# ACCESS AUDIT REPORT

# GANDHI SMRITI

20<sup>th</sup> October 2009

**National Centre for Accessible Environments**

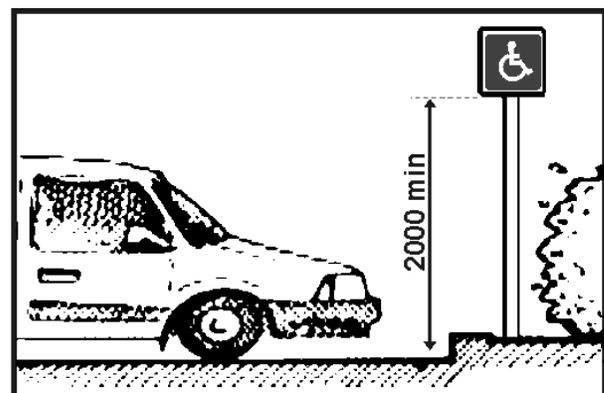
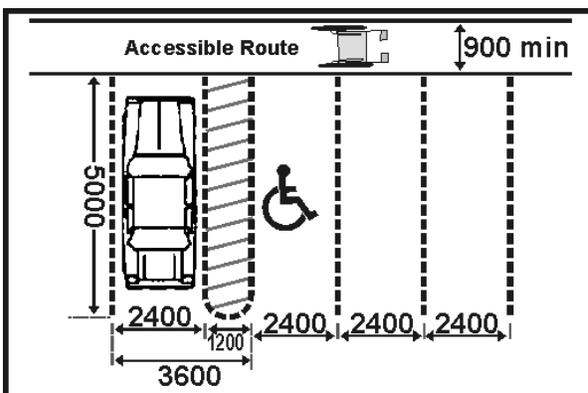
Another entrance shown in photo is used for general public entry. However ramp has been provided only on one side of raised pavement.

Reserved parking has not been provided for visitors and staff with mobility impairments.

- ✚ An inward cut ramp to be also provided on the road side of the raised pavement.
- ✚ Gradient of ramp to be minimum 1:12. Refer Annexure I.
- ✚ Tactile Guiding and warning tiles (refer Annexure IV for engineering configuration) are proposed for persons with low vision and vision impairment. Warning strip to be provided 300mm before and after the ramp and step edges, so that a person with vision impairment does not trip accidentally.
- ✚ Signage for ramp to be provided.
- ✚ The guiding path should lead to important amenities/facilities such as ramps to building entrances and clearly avoid vehicle movement areas. This benefits everyone including persons with disabilities.
- ✚ Wheelchairs may be provided on request for visitors with reduced mobility.

- ✚ Parking should be within 30 meters of the entrance to the building.
- ✚ Space for two reserved accessible parking has been identified as shown in above photos.
- ✚ Two accessible parking lots with overall minimum dimension 3600mm x 5000mm, should be provided.
- ✚ All security guards/staff should be sensitized and well informed about these reserved parking for Persons with Disabilities (PwDs).

**Side entrance**

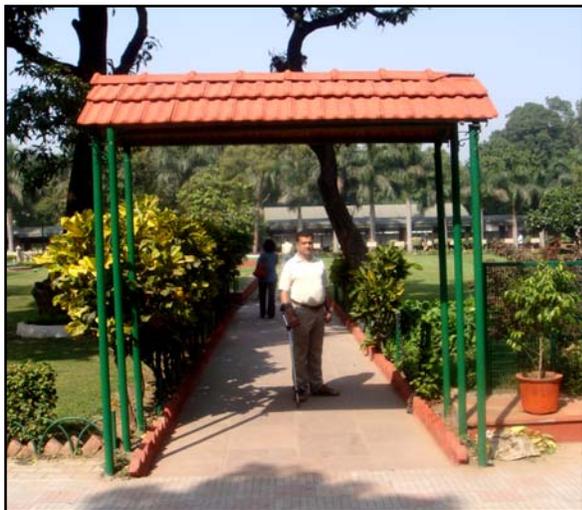
Main entrance is marked by steps.

Another entrance from the side is proposed to be made accessible for PwDs.

- Access symbol to be provided at this entrance for easy identification.
- Directional signage to be provided at the main entrance informing accessible side entrance.

**Figure II (Proposed)**

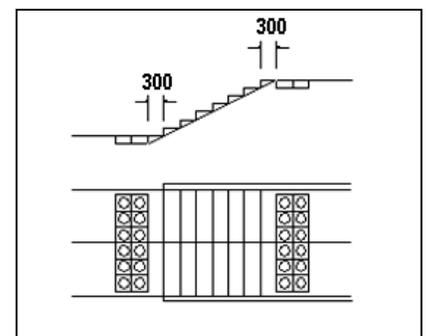
The existing two ramps are steep and not placed in a line (figure I).  
The main entrance door has a step 180mm high (figure II).

✚ Accessible entrance is proposed by providing gentle mergers and ramp (as illustrated).

✚ Warning strip (Annexure IV) to be provided 300mm before and after the ramp edges, so that a person with vision impairment does not trip accidentally.

**Thick coir foot mat**

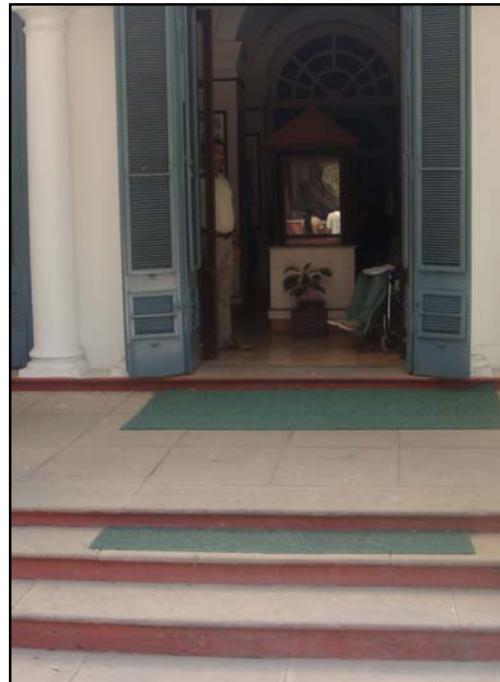
It is difficult to move mobility aids on thick coir mats and it can pose trip hazard.

- ✚ Thick coir foot mats to be replaced by rubber mats, as shown in photo at right.
- ✚ Foot mats are good orienting cue for persons with vision impairment and low vision and should be placed for all entrances.

Existing lift

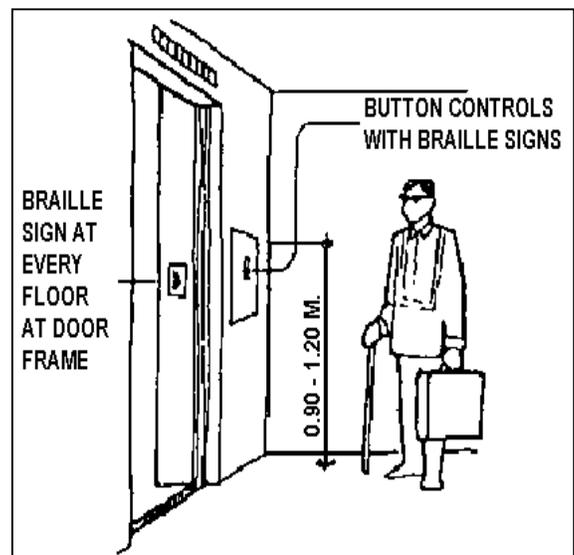
Call buttons (height 1250mm) are placed out of reach of persons seated in wheelchair.

Elevator car floor size is 1100mm x 1400mm and door width is 800mm, which can accommodate wheelchair with difficulty. Grab bar have been provided however, review mirror and audio floor announcement are missing.

- Call button should be placed at a reach of 900mm-1000mm; at least 400mm from any corner or have a clear floor space of at least 900 mm x 1200 mm with no obstruction placed to prevent a wheelchair user from reaching the call button.

- Minimum space required for wheelchair users is 1400mm x 1400mm.

Examples of room signage - difficult to read due to small font size, colour combination

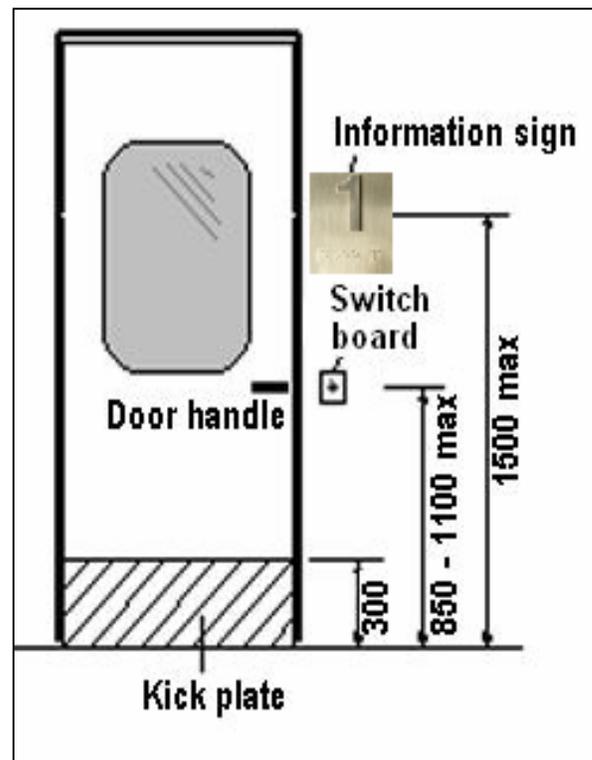
Room signage is mounted above eye level.

- ✚ Metal signages should be avoided as it produces glare.
- ✚ Signs should be mounted between 1400mm and 1600mm from floor level on the wall (preferably on latch/ door handle side of all doors).
- ✚ The individual characters to be between 15mm-50mm tall and raised by 1-1.5mm.
- ✚ **Signage, nameplates and numbers** of the rooms to be in Braille & raised alphabets, bold & color contrasted with their background.

**Existing**

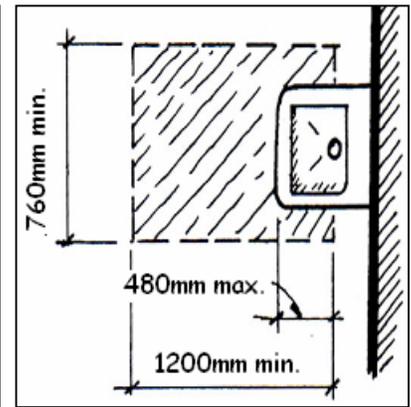
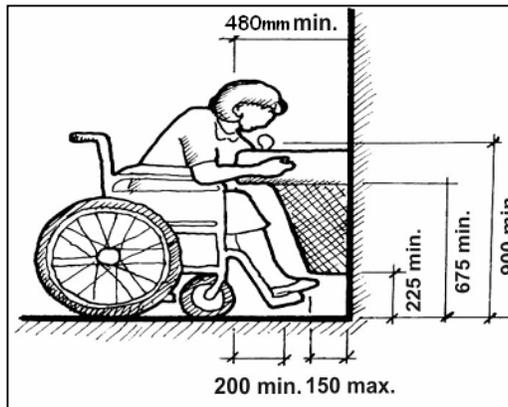
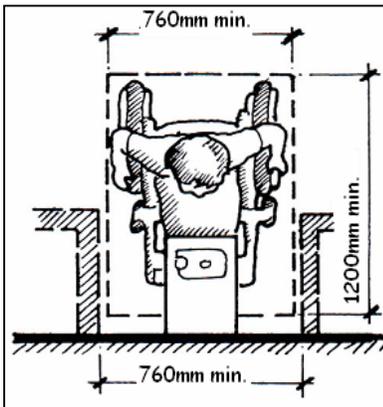
Existing tap height is 2000mm, which is out of reach of persons using wheelchair.

- ✚ Lowered tap with basin to be provided (as illustrated) for persons using mobility aids such as wheelchair.
- ✚ All operable parts to be between 900mm-1000mm height.
- ✚ Leg and knee space to be provided (as shown in the diagrams) with basin to avoid spilling of water.
- ✚ This allows both front and parallel access to taps for persons using mobility aids like wheel chair, crutches etc.

**Proposed ramp and sliding door for accessible toilet**

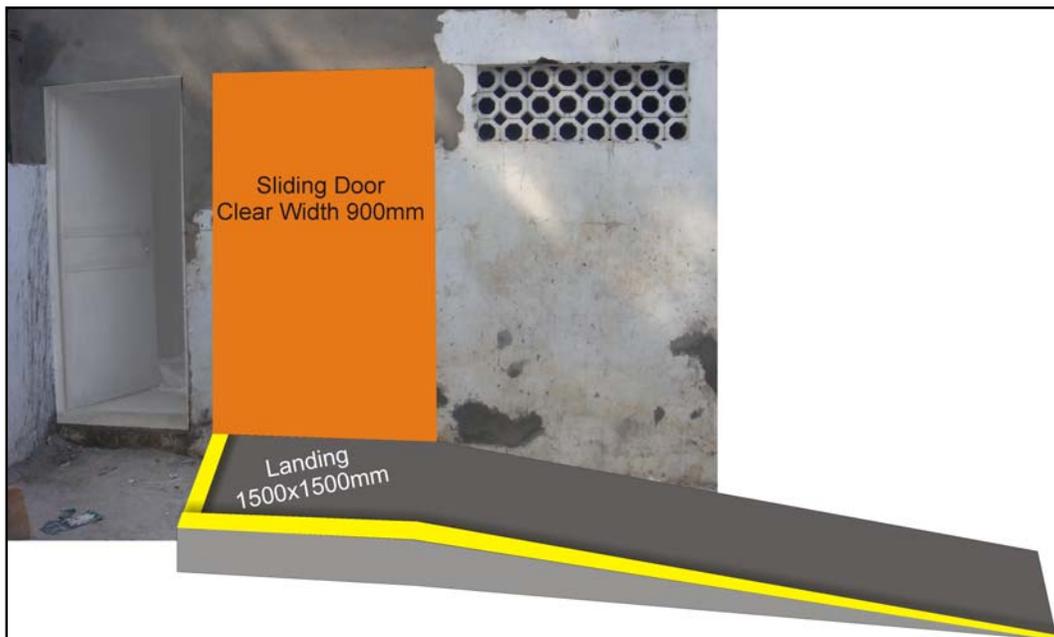
An accessible multiuse toilet is proposed in one cubicle of the existing toilet block under renovation. However, there is a step and door (opens inside) needs to be relocated.

Existing toilet size is 1800mm x 4500mm which is suitable for conversion to accessible multiuse toilet.

- ✚ L shape ramp (maximum gradient 1:12) with landing 1500mm x 1500mm and edge protection to be provided as illustrated.
- ✚ Existing door to be relocated and a sliding door (minimum clear width 900mm) in the center to be provided as illustrated above.
- ✚ Refer Annexure I for ramp standards.
- ✚ Refer Annexure VI for accessible toilet standards and signage.
- ✚ Directional signage for accessible multiuse toilet to be included in internal way finding signage and also placed near other general toilets.
